Access Compliance Report Public Rights-of-Way (Curb Ramps)

Main Street: KENSINGTON_RD		Cross Street: GERTRUDE_DR		Location:	NE
ADA ID: RPRK211220141635	Ramp Type: Type 1 - Perpendicular Diagonal Initial Pass/Fail: Pass		Overall Compliance: No	Severity Score:	10

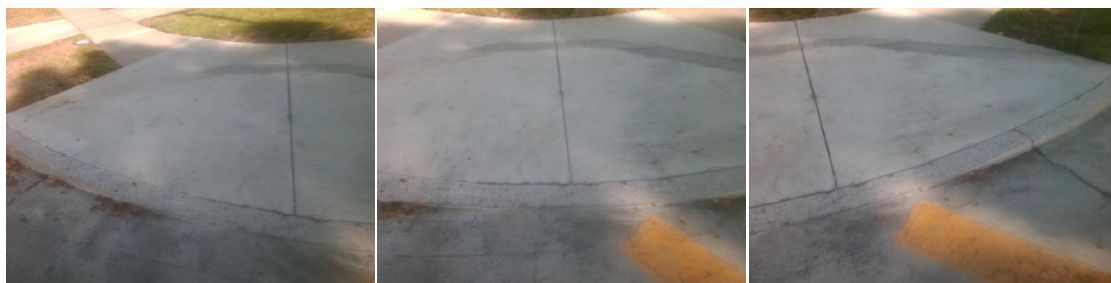
Compliance	Description	Data	Compliance	Description	Data
N/A	Ramp Length (in)	83	N/A	Flare Type LT	
Yes	Ramp Width (in)	48			Sloped
Yes	Ramp Run Slope (%)	8	N/A	Flare Slope LT (%)	5.5
Yes	Ramp Cross Slope (%)	0.5	N/A	Flare Traversable LT	No
N/A	Landing Present	Yes	N/A	Flare Type RT	
N/A	Landing Length (in)	48			Sloped
Yes	Landing Width (in)	48	N/A	Flare Slope RT (%)	5
No	Landing Run Slope (%)	2.6	N/A	Flare Traversable RT	No
Yes	Landing Cross Slope (%)	1.2	No	DWS Provided	No
N/A	Landing Movement Obstructed?	No	N/A	DWS Contrast	N/A
	Landing Movement Type	N/A	N/A	DWS Length (in)	N/A
N/A	Landing Shared	No	N/A	DWS Full Width	N/A
N/A	Clear Space	Yes	N/A	DWS Offset Left (in)	N/A
N/A	Clear Space To Crosswalk (in)	48	N/A	DWS Offset Right (in)	N/A
N/A	Marked Crosswalk 1	No	N/A	Marked Crosswalk 2	Yes
	Crossing 1 Direction	W		Crossing 2 Direction	S
	Marked Crosswalk 1 Width (in)	N/A		Marked Crosswalk 2 Width (in)	144
N/A	Ramp Inside Crosswalk 1	N/A	Yes	Ramp Inside Crosswalk 2	Yes

Crossing 1 Slope (%)	2.8		Crossing 2 Slope (%)	4.7
	Crossing 1 Cross Slope (%)	1.7		Crossing 2 Cross Slope (%)	0.7
Yes	Gutter Ponding	No	Yes	Curb Slope	2.3
Yes	Gutter Lip Height (in)	0		Road Run Slope (%)	0.3
Yes	Gutter Run Slope (%)	0.2		Road Cross Slope (%)	0.1
Yes	Gutter Cross Slope (%)	0			
Yes	Overall Surface Condition: Acceptable		No	Perp Joint Present	No
	Cross Gutter Present?	Yes		Spandrel Present?	Yes
	Replace Cross Gutter?	No		Replace Spandrel?	No

Possible Solutions:

Remove & Replace Curb Ramp With Two New Directional Ramps or Equivalent.
